PERMIT

SEWAGE DISPOSAL SYSTEM

MARYLAND STATE DEPARTMENT OF HEALTH

PROPERTY OWNER EDWIN A. GENTRY

INDICATE NORTH. — NAME ADJOINING ROADWAY AS BASE LINE.

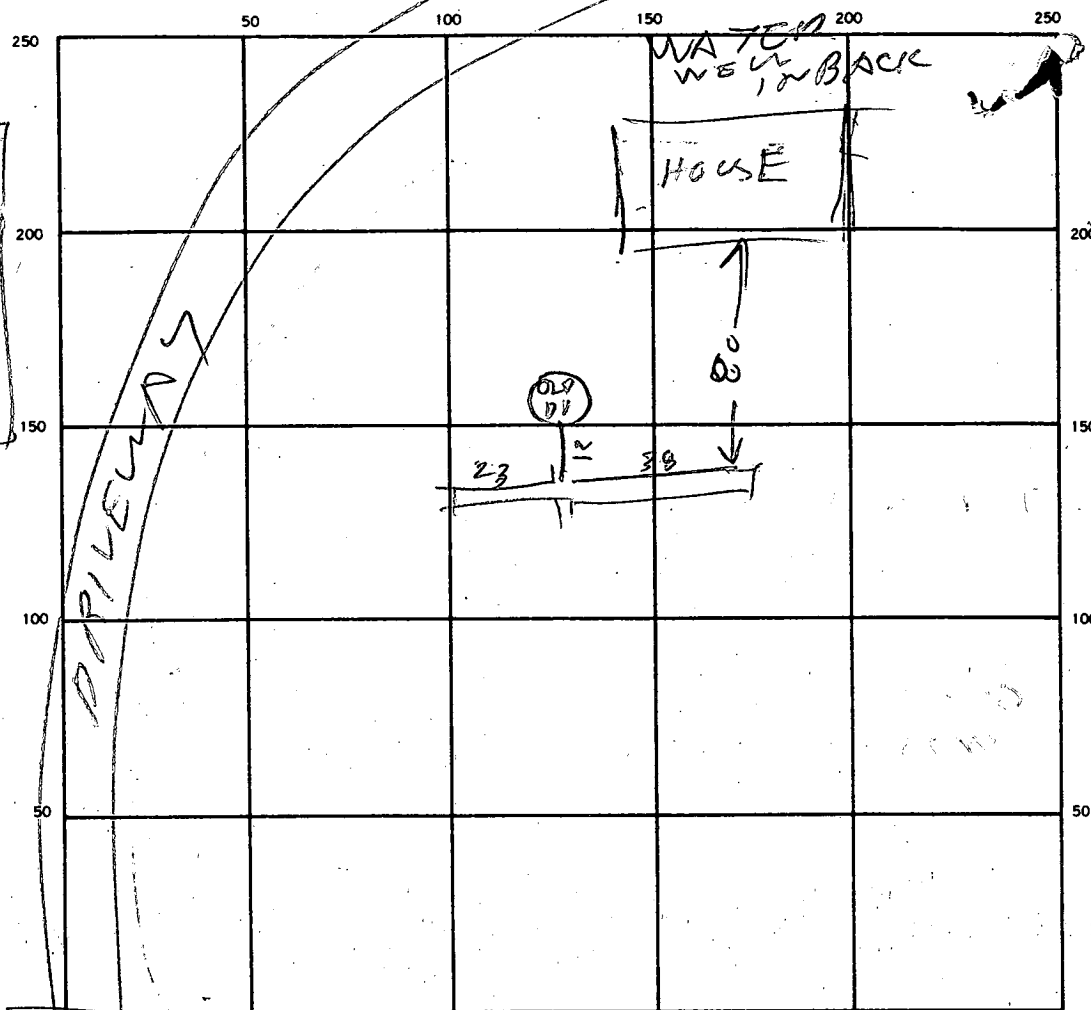
REMARKS 5/28/87 3PM DITCH DUG 41 FT LONG & 11 FT
DEEP. DIG TRENCH DEEPER AND ADD STONE
5/28/87 350 PM STONE ADDED & TRENCH
LENGTHENED

DRAIN FIELD/TILE FIELD. DEPTH 11 FT. TRENCH WIDTH 2 FT. INLET DEPTH 4 FT.

EFFECTIVE GRAVEL DEPTH 6.5 FT. TOTAL LENGTH 61 FT. (INSTALLED) REQUIRED

NUMBER OF TRENCHES 1 ONE SIDEWALL/BOTTOM AREA 394 SQ. FT. 375
